Sample Reviewed Drawing Set

An AI pass over three sheets of a fictional municipal servicing set.

ROADWORKS AND WATERWORKS
"B" AVENUE EAST OF STREET 2
ADDRESS (TYP.)

SANITARY AND STORM SEWER
"B" AVENUE EAST OF STREET 2
ADDRESS (TYP.)

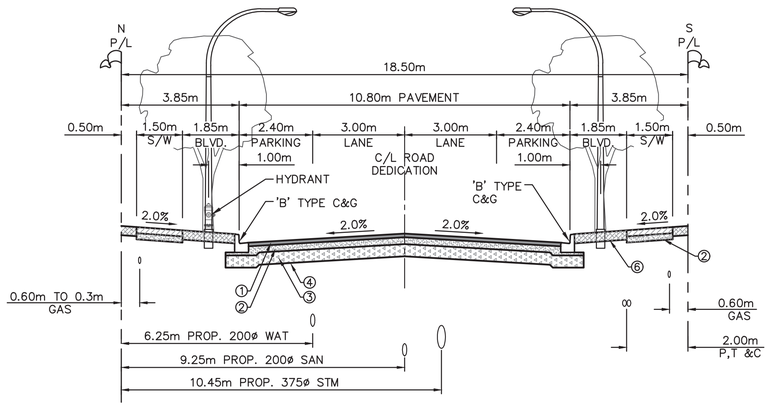
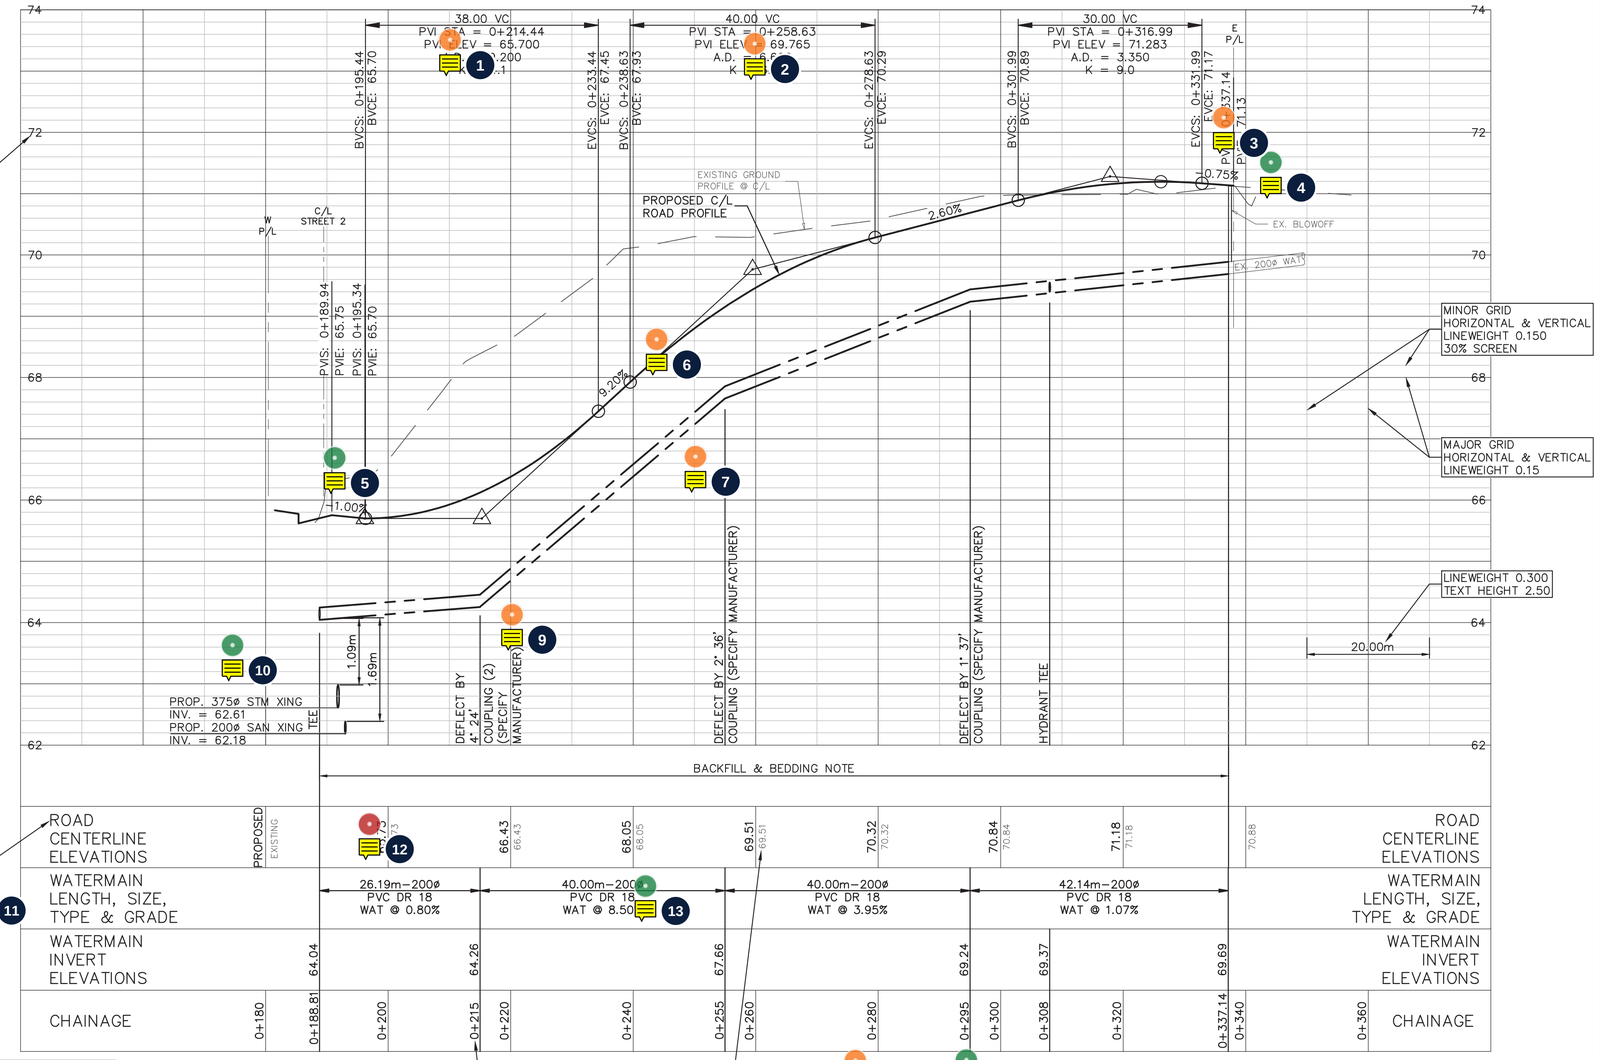
Finding: The sag vertical curve VC 1 at PVI 0+214.44 has an algebraic difference A.D. = 9.20% and length L = 38.00m, resulting in K = 4.1. Section 8.7.3.3 specifies an equivalent K-value of 4 for maximum grade changes outside intersections; headlight sight distance should be confirmed for 50 km/h design speed.

Finding: The active standard defers curve minimums to TAC, so no deterministic verdict is issued. Verify the following against the TAC tables for the road's design speed (road class could not be resolved from the sheet — confirm it first): 0+195.44 to 0+233.44: K=4.1; 0+238.63 to 0+278.63: K=6.1; 0+301.99 to 0+331.99: K=9.

Finding: The watermain profile rises over 5.6m to a summit invert of 69.69m near station 0+337.14 without providing a combination air release valve. Section 3.4.5 requires combination air valves at high points of mains 200mm diameter and larger where air pockets can accumulate.

Finding: All 4 water pipe segments meet the 0.75m minimum cover in the below segments.
• TEE to COUPLING: 1.51m
• COUPLING to COUPLING: 1.285m
• COUPLING to COUPLING: 1.27m
• COUPLING to TIE-IN: 1.033m
NOTE: this standard sets road-class-dependent cover minimums; the check uses the LOWEST (0.75m) — verify the road class for any segment near the threshold, as a higher-class road may require more.

Finding: Longitudinal roadway grades along B Avenue (-1.00%, +9.20%, +2.60%, -0.75%) all exceed the minimum required 0.5% longitudinal grade for streets with concrete gutters established in Section 8.7.3.3.

Finding: The roadway longitudinal tangent grade between EVCS 0+233.44 and BVCS 0+238.63 is 9.20%. While within the absolute maximum of 10% for streets with concrete gutters under Section 8.7.3.3, it significantly exceeds the preferred maximum grade of 1.5%.

Finding: This sheet shows 5 watermain fittings but NO joint restraint or thrust block table was found anywhere in the set, so neither a restrained length nor a block size is stated for any of them. This is NOT a compliant verdict.

Finding: Watermain vertical deflection couplings at stations 0+215 (4°24'), 0+255 (2°36'), and 0+295 (1°37') indicate '(SPECIFY MANUFACTURER)' and Note 9 specifies CertainTeed couplings for bends under 3 degrees, but joint restraint lengths and thrust restraint details are omitted contrary to Section 2.4.8.

Finding: At station 0+188.81, proposed 200mm watermain crosses over proposed 375mm storm main with 1.09m vertical clearance, and crosses over proposed 200mm sanitary sewer main with 1.69m vertical clearance. Both crossings exceed the minimum vertical clearance requirement of 0.45m above sewers per Section 2.2.5.

Finding: The proposed 200mm watermain is specified as PVC DR 18 pipe. Section 3.4.2.2 requires distribution mains to be ductile iron with a minimum 200mm diameter, and Section 3.5.3 specifies ductile iron pipe for distribution mains.

Finding: General notes on the drawing do not include mandatory notification of the Land Survey Branch prior to construction or monitoring procedures for integrated survey monuments within 2.0m radius as required by Section 2.3.5.6.

Finding: Thrust blocks and joint restraints are indicated by text labels ('c/w THRUST BLOCK') but are not sized, shaded, labelled, or dimensioned from adjacent fittings showing the length requiring restraint as required by Section 2.4.8.

Finding: Mainline tee at station 0+188.81 (Street 2) and hydrant tee at station 0+308 call for 'c/w THRUST BLOCK' but omit required thrust block dimensions, bearing area calculations, and shading per Section 2.4.8.

Finding: Sheet 6's 3m lane width (printed on this sheet; 0+189.94 to 0+195.44, 0+195.44 to 0+233.44, 0+233.44 to 0+238.63, 0+238.63 to 0+278.63, 0+278.63 to 0+301.99, 0+301.99 to 0+331.99) meets the 2.7m minimum in §8.7.3.1 ("Roadway Lane Widths"). The standard states road-class-dependent minimums; the check uses the LOWEST — a higher-class road may require more.

Finding: Single diagonal curb ramps are shown at curb returns C1 and C2 at the intersection of B Avenue and Street 2. Section 8.8.1.1 specifies double curb ramps per corner as standard (Standard Detail Drawing C8.1) and requires City Engineer approval for single diagonal ramps.

Finding: Curbs are specified as "B' TYPE C&G AS PER MMCD DWG C4'. Section 8.7.4 indicates Type B shallow-depth barrier curb and gutter requires specific City approval, with Type A standard barrier curb and gutter (0.15m face) being standard for motor vehicle separation.

Finding: The front boulevard between curb and sidewalk is dimensioned as 1.85m softscape. Section 8.4.6 requires a minimum front boulevard width of 2.0m (preferred > 2.0m) for residential streets, though 1.2m is permitted under constrained conditions.

Finding: The callout '25mm WATER SERVICE (TYP.)' does not specify the pipe material. Section 3.4.2.2 and Section 3.5.3 specify copper as the preferred material for small diameter service connections under 100mm.

Finding: The back boulevard between the concrete sidewalk and property line is dimensioned as 0.50m. Section 8.4.6 specifies a minimum back boulevard width of 1.2m (preferred 1.5m) for residential streets, though a constrained minimum of 0.3m is allowable.

Finding: The upper landing area at curb ramps C1 and C2 is constrained by the 1.50m sidewalk width and 0.50m back boulevard. Section 8.8.1.1 requires a minimum landing area of 1.2m (0.9m absolute minimum) clear of obstructions at the top of all curb ramps.

Finding: No truncated dome surfaces (TWSI) are specified or detailed on the curb ramps at C1 and C2. Section 8.4.1.4 mandates safety yellow truncated dome surfaces (TWSI) on pedestrian crossings with grade breaks less than 5% between sidewalk and ramp.

Finding: Proposed 200mm watermain runs parallel to proposed 200mm sanitary sewer from station 0+188.81 to 0+347 at 3.00m centerline spacing (offsets 6.25m and 9.25m), resulting in an edge-to-edge separation of 2.80m, which violates the 3.0m minimum clearance required by Section 2.2.5. Proposed watermain runs parallel to proposed 375mm storm sewer at 4.20m centerline spacing (offsets 6.25m and 10.45m), resulting in 3.91m edge-to-edge separation, which complies with the 3.0m requirement.

Finding: The drawing title block contains placeholder text ('MUNICIPAL PROJECT No. xx-xx-xxxx', 'XYZ', 'LOGO', 'PLAN No. XYZ-', 'of XX') omitting official project identifiers, engineer seals, and revision dates required for formal submission under Section 2.5.10.

Finding: The title block specifies horizontal scale 1:500 and vertical scale 1:50. Section 2.4.1.5 specifies 1:500 H / 1:50 V for waterworks plan & profile, but requires 1:250 H and 1:10 or 1:25 V for streets/transportation plan and profile drawings.

Action: Review sag curve K-value (K=4.1) against TAC Geometric Design Guide headlight sight distance requirements for urban local roadways per Section 8.7.3.3.

Action: Check each listed K / radius against the TAC minimum for the governing design speed.

Action: Review hydraulic profile with the City Engineer to determine if a 25mm combination air valve is required at the profile summit in accordance with Section 3.4.5.

Action: Verify that the 9.20% roadway grade meets municipal accessibility and operational criteria, or flatten vertical alignment if site topography permits per Section 8.7.3.3.

Action: Provide a joint restraint table or thrust block schedule covering every fitting size and deflection used, or point to the standard drawing that does.

Action: Size, label, and dimension joint restraints from adjacent fittings showing the restrained length in accordance with Section 2.4.8.

Action: Revise distribution main pipe specification from PVC DR 18 to Ductile Iron conforming to Section 3.4.2.2 and Section 3.5.3.

Action: Add mandatory survey control note requiring Land Survey Branch notification prior to construction at or near any integrated survey monument per Section 2.3.5.6.

Action: Size, shade, label, and dimension joint restraints and thrust blocks on plan and profile views showing restrained lengths per Section 2.4.8.

Action: Provide engineered thrust block dimensions, concrete bearing area details, and shading or specify mechanical joint restraint lengths conforming to Section 2.4.8.

Action: Provide double directional curb ramps per corner per Standard Detail Drawing C8.1, or obtain City Engineer approval for single diagonal ramps under Section 8.8.1.1.

Action: Confirm City Engineer approval for Type B shallow-depth barrier curb and gutter or revise to standard Type A curb per Section 8.7.4.

Action: Widen front boulevard to minimum 2.0m if right-of-way permits, or confirm constrained residential boulevard width with the City Engineer per Section 8.4.6.

Action: Specify copper pipe material for all 25mm service connections in accordance with Section 3.4.2.2 and Section 3.5.3.

Action: Confirm back boulevard width meets constrained residential criteria or adjust layout to achieve 1.2m minimum back boulevard per Section 8.4.6.

Action: Verify and detail a minimum 1.2m unobstructed planar landing area at the top of each curb ramp per Section 8.8.1.1.

Action: Install safety yellow cast iron or composite truncated dome tactile surfaces (TWSI) on all curb ramps in accordance with Section 8.4.1.4 and Standard Detail Drawings C8.5-C8.7.

Action: Adjust utility alignment offsets to provide a minimum 3.0m edge-to-edge horizontal clearance between the watermain and sanitary sewer main in accordance with Section 2.2.5.

Action: Populate all title block fields with valid project numbers, engineer seals, professional signatures, drawing numbers, and revision history in compliance with Section 2.5.10.

Action: Confirm with City Engineer whether a dual-discipline sheet at 1:500 H / 1:50 V is acceptable or provide dedicated streets plan and profile drawings at 1:250 H per Section 2.4.1.5.

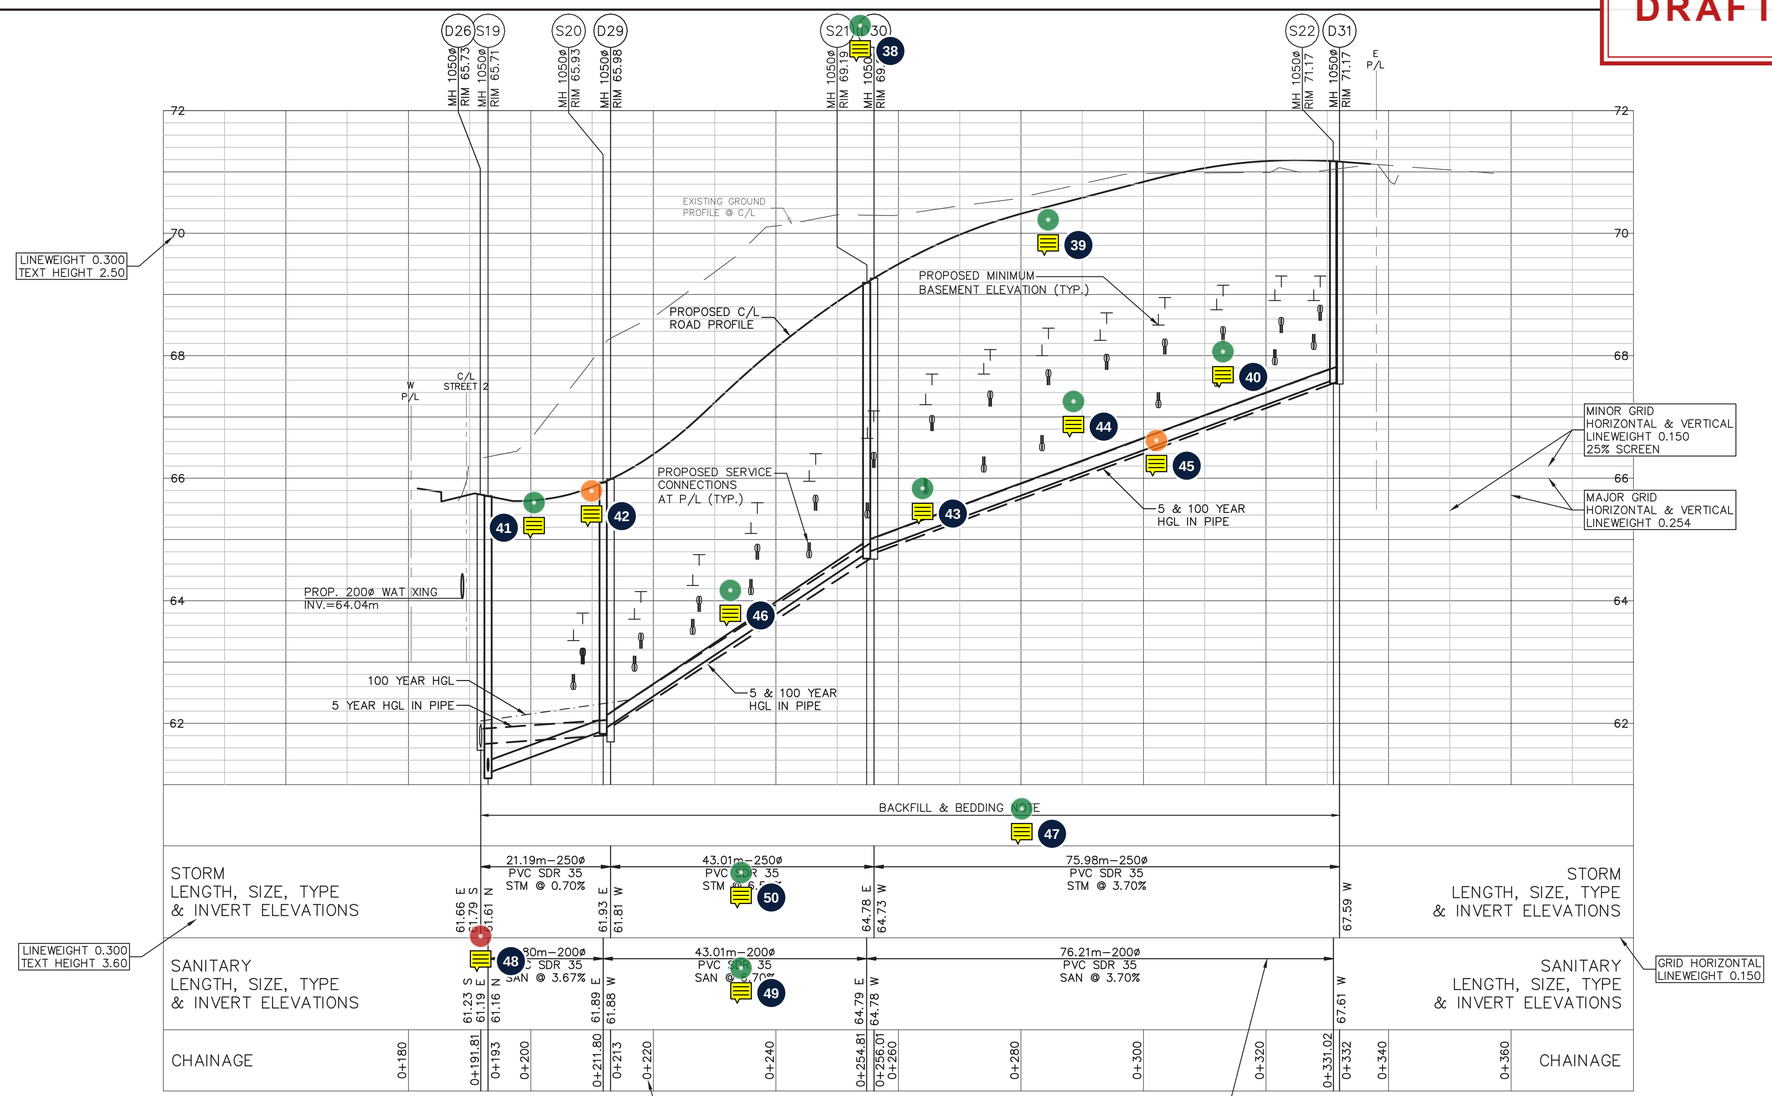
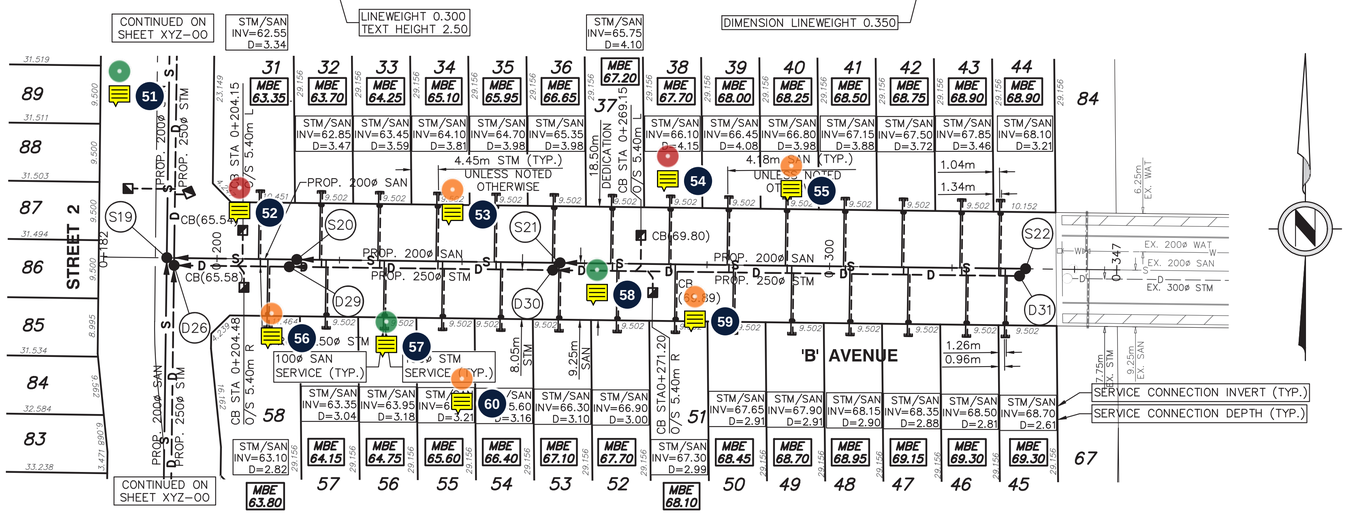
Finding: All proposed maintenance holes (D26, S19, S20, D29, S21, D30, S22, D31) are specified with 1050mm inside diameter precast concrete barrels ('MH 1050ø'), which fully complies with Table 4-5 and Table 5-12 for pipe diameters up to 450mm under Section 4.4.3.3 and Section 5.4.3.3.

Finding: Cover not verifiable — manual check required for: D26 to D29. (Cover could not be computed deterministically, e.g. at a drop manhole or an unmatched endpoint.)

Finding: The sewer profile view omits the CCTV bar indicating service wye takeoff locations along the proposed mains, and does not annotate modeled design flow (QD) or full-flow pipe capacity (QF) in cubic metres per second as required by Section 2.4.7.

Finding: At sanitary manhole S19 (Stn 0+193), the pipe alignment deflects 90 degrees from east to north, but the provided invert drop across the manhole from inlet (61.19m E) to outlet (61.16m N) is only 30mm (0.03m), violating the mandatory minimum drop requirement of 50mm for alignment deflections between 45° and 90°.

Finding: The road centerline and gutter profile create a localized sag / low point near Station 0+204 (CB rim elevations 65.54m at Stn 0+204.15 and 65.58m at Stn 0+204.48, compared to 65.71m-65.73m at the Street 2 intersection), but the design proposes single catchbasins rather than mandatory double catchbasins with side inlet (leafcatcher).

Finding: Proposed 200mm Sanitary Sewer and Proposed 250mm Storm Sewer run parallel along 'B' Avenue from Stn 0+191.81 to Stn 0+332 with stated offsets of 9.25m SAN and 8.05m STM from the south property line (1.20m center-to-center, ~0.96m edge-to-edge); while this exceeds the 0.3m common trench minimum, no explicit horizontal clearance dimension line is annotated on the plan, requiring field verification to ensure clear separation is maintained throughout.

Finding: All 28 proposed sanitary and storm service connections along 'B' Avenue exhibit invert depths at the property line ranging from 2.61m to 4.15m below ground (e.g. Lot 38 D=4.15m, Lot 39 D=4.08m, Lot 35 D=3.98m, Lot 34 D=3.81m), which substantially exceed the absolute maximum allowable depth of 2.4m at the property line without documented engineering justification or City Engineer approval.

Finding: Sanitary (100mm) and storm (150mm) service connections to residential lots are dimensioned at 0.27m center-to-center (e.g. 4.18m SAN and 4.45m STM from lot line), yielding an edge-to-edge horizontal clearance of approximately 0.13m, which is less than the mandatory 0.3m minimum horizontal clearance required for utility assets in a common trench under Section 2.2.5.

Finding: All 28 proposed sanitary service connections terminate at the property line without showing or specifying sanitary inspection chambers (fitted with red lids) located 0.3m outside the property line on the City street side as mandated by Section 4.6.6 and Standard Detail Drawing S7.1.

Finding: The profile vertical scale is designated as 1:50 in the title block and profile grid, whereas Table 2-4 of Section 2.4.1.5 specifies a mandatory vertical scale of 1:100 for standard Storm / Sanitary Plan and Profile drawings (with 1:500 horizontal).

Action: Manually verify cover against the 1m minimum for these segments.

Action: Add a CCTV bar along the sewer profile showing wye takeoff locations, and annotate design flow (QD) and full-flow pipe capacity (QF) in cubic metres per second in accordance with Section 2.4.7.

Action: Lower the outgoing north invert at manhole S19 to 61.14m or higher the incoming east invert to achieve a minimum invert drop of 50mm across the 90-degree junction in accordance with Section 4.4.3.4.

Action: Replace the single catchbasins at the road low point with double catchbasins with leafcatcher (side inlet) conforming to Standard Detail Drawing S11.1 as required by Section 5.4.4.1.

Action: Add an explicit horizontal dimension line between parallel storm and sanitary sewer centerlines/walls verifying at least 0.3m edge-to-edge clearance in common trench per Section 2.2.5.

Action: Redesign service connection profiles or adjust main elevations so that invert depths at the property line do not exceed the absolute maximum depth of 2.4m as per Section 4.6.3 and Section 5.6.3, or submit formal depth exception documentation for City Engineer review.

Action: Increase lateral spacing between storm and sanitary services to provide at least 0.3m clear edge-to-edge separation in common trench excavations as required by Section 2.2.5.

Action: Add sanitary inspection chambers with red lids 0.3m outside the property line for each proposed service connection conforming to Section 4.6.6 and Standard Detail Drawing S9.1.

Action: Provide storm inspection chambers with green lids 0.3m outside the property line on all storm service connections per Section 5.6.6.

Action: Replace placeholder 'XYZ' text with active City survey control monument numbers, reference coordinates, datum (CGVD28 / NAD83 CSRS), and benchmark elevations per Section 2.4.3.

Action: Update the profile vertical scale to 1:100 in conformance with standard metric drawing scales in Table 2-4 of Section 2.4.1.5.
